Re: Lot 11 & Lot 12, Block 1 Minerva
Park Subdivision

Re: **Request for TEDS Exemption for Access Spacing**

Re: Design Exception #DE09-06 – Lots 11/12, Block 1, Minerva Subdivision –
Driveway Spacing on W. Crete Circle.

DESIGN EXCEPTION # 9-06

PEROUIS PROPERTY
TEDS EXEMPTION EXHIBITS
LOT 11 & 12, BLOCK 1 MINERVA PARK
GRAND JUNCTION, COLORADO
 prepared by
CACHE PROPERTIES, INC.

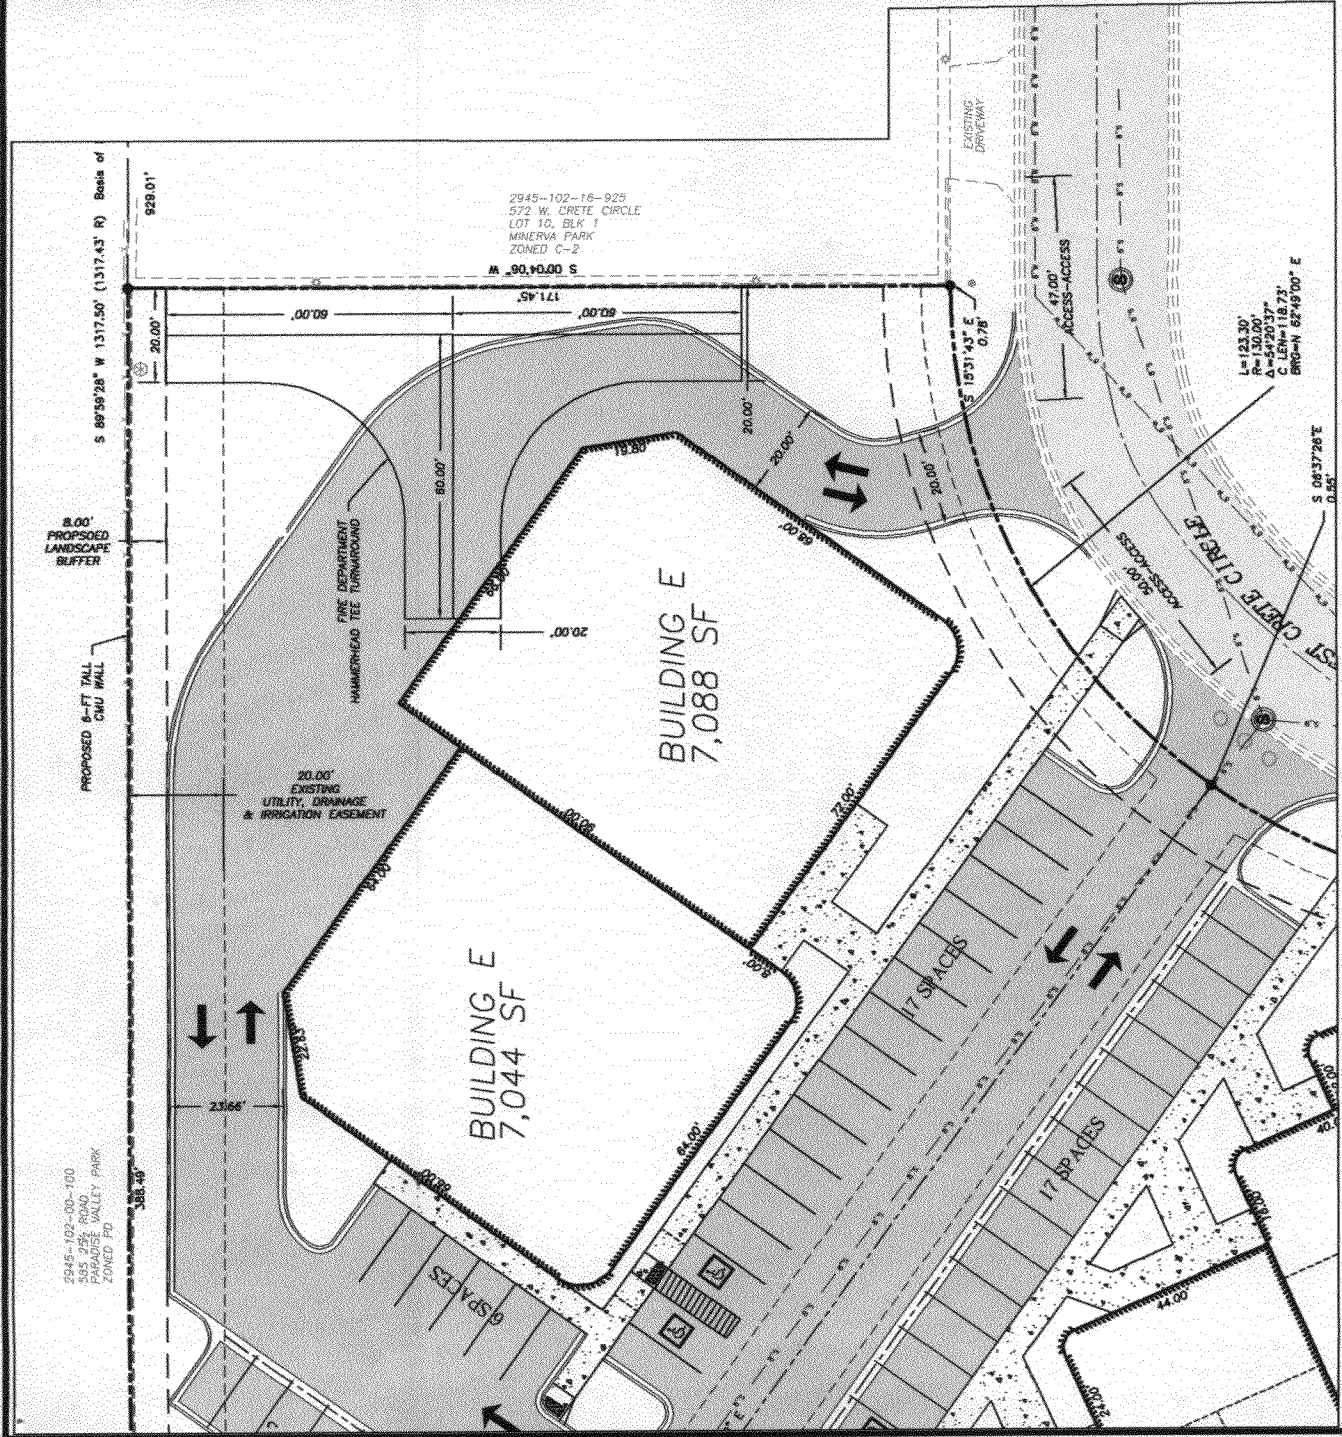
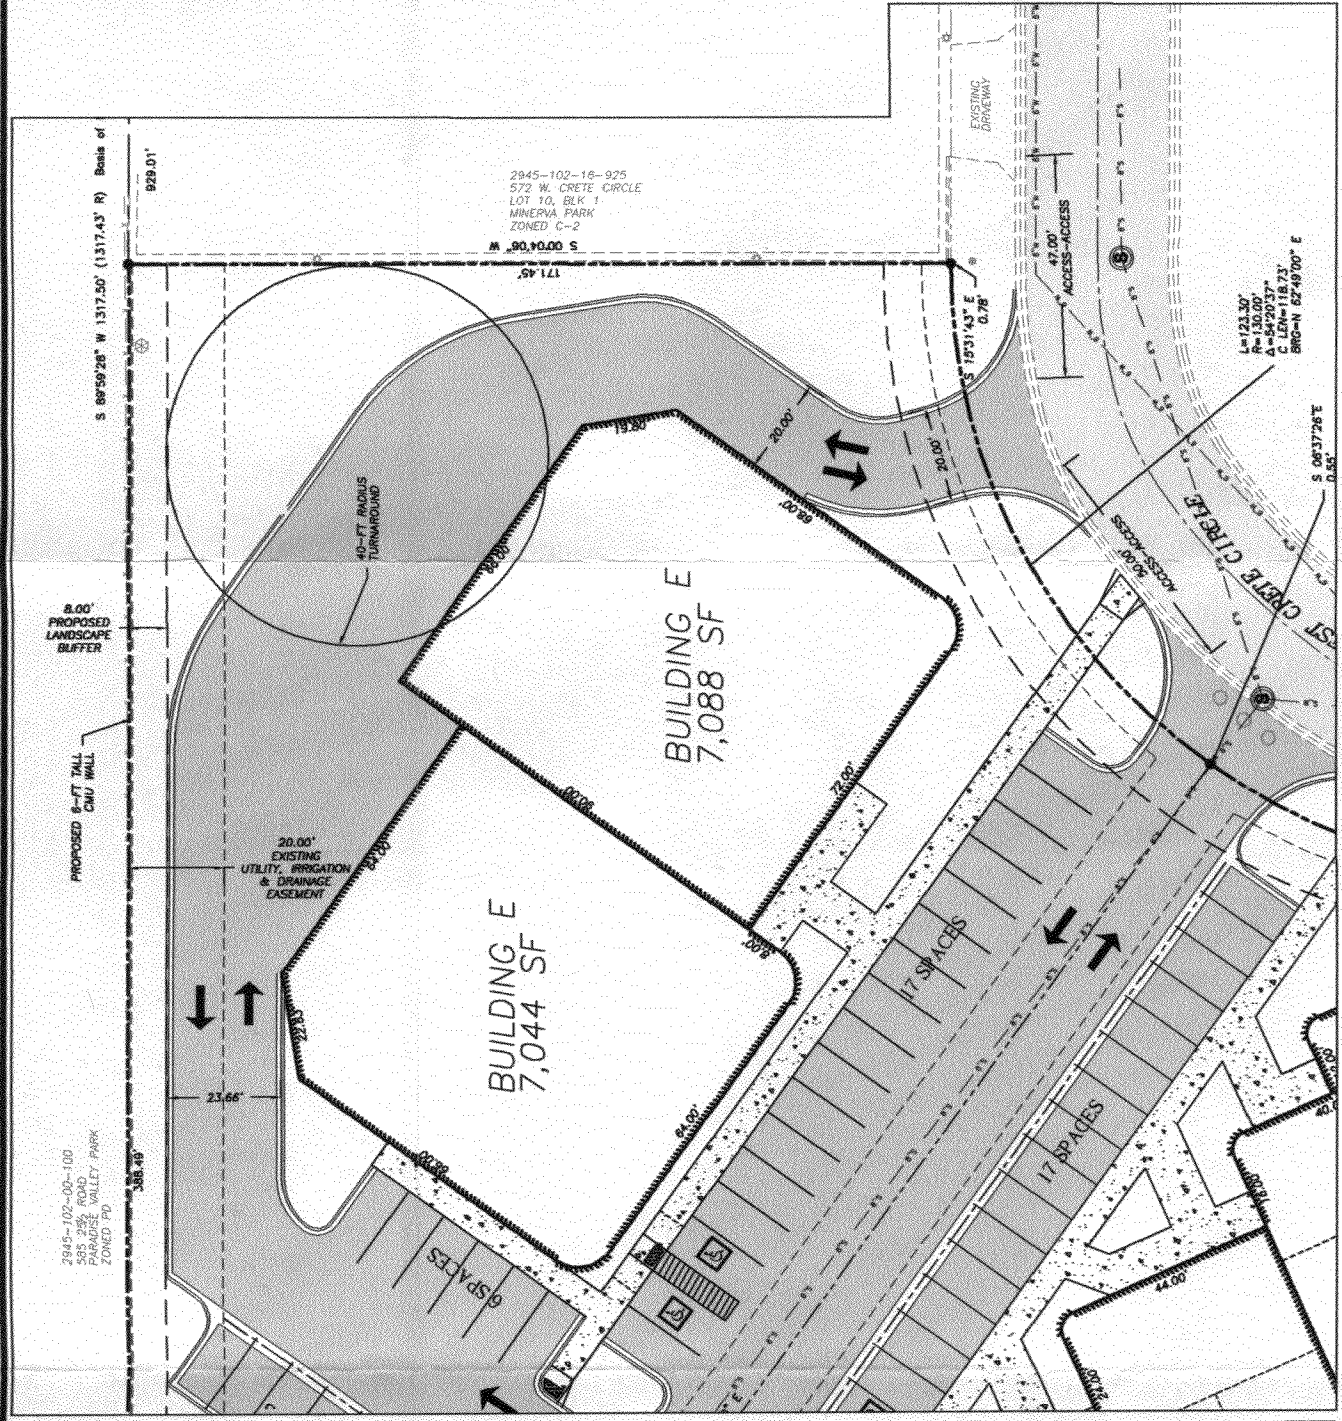
Of the secondary accesses, the southern most access will provide access from West Crete Circle to Buildings A-D. This access has been spaced approximately 10-ft north of the southern property line and approximately 69.55-ft from the main access to the site. The northern most secondary access, will provide access from West Crete Circle to Buildings E & F. This access has been spaced 50-ft from the main access and limited to only 47-ft from the adjacent driveway on 572 West Crete Circle.

While the northern secondary access does not meet TEDS 50-ft of minimum spacing for driveways on local streets, the site has Fire Department constraints that need to be taken into account as part of this exemption request.

1. Overall length of loop lane exceeds Fire Department 150-ft maximum length without an approved turn around area.
2. The area behind Building E & F is not large enough to provide an approved Fire Department turn around without encroaching the northern property landscaping requirement of 8-ft wide landscape buffer and encroaching the adjacent property.

Attached drawings demonstrate the proposed development and constraints that prohibit an approved Fire Department turn around along the rear of Building E & F.

- If granted, will the exception compromise safety?
 - o No. The accesses will be on an isolated local commercial/industrial street with very little traffic volume.
- Have other alternatives been considered that would meet current standards?
 - o Yes. It is possible to meet current access spacing standards by eliminating one of the proposed accesses, but such a configuration causes awkward dead-end circulation onsite.
- Has the proposed design been used in other areas?
 - o Yes, access spacing on local streets is probably the most commonly approved TEDS exception.
- Will the exception require CDOT or FHWA coordination?
 - o No.
- Is this a one-time exception based upon unique circumstances – location, topography, traffic flow, etc?
 - o No.
- If not a one-time exception, is manual revision needed?
 - o No.

This proposed exception is not absolutely necessary to make the site design work. However, I don't believe the exception will cause an unsafe condition, and probably does improve the onsite circulation.

- 1. Will the exception compromise safety?**
Staff does not believe the exception will compromise safety.
- 2. Have other alternatives been considered that would meet the standard?**
Yes. It is possible to meet current access spacing standards by eliminating one of the proposed accesses, but such a configuration causes awkward dead-end circulation onsite.

Staff recommends approval of the exceptions requested.
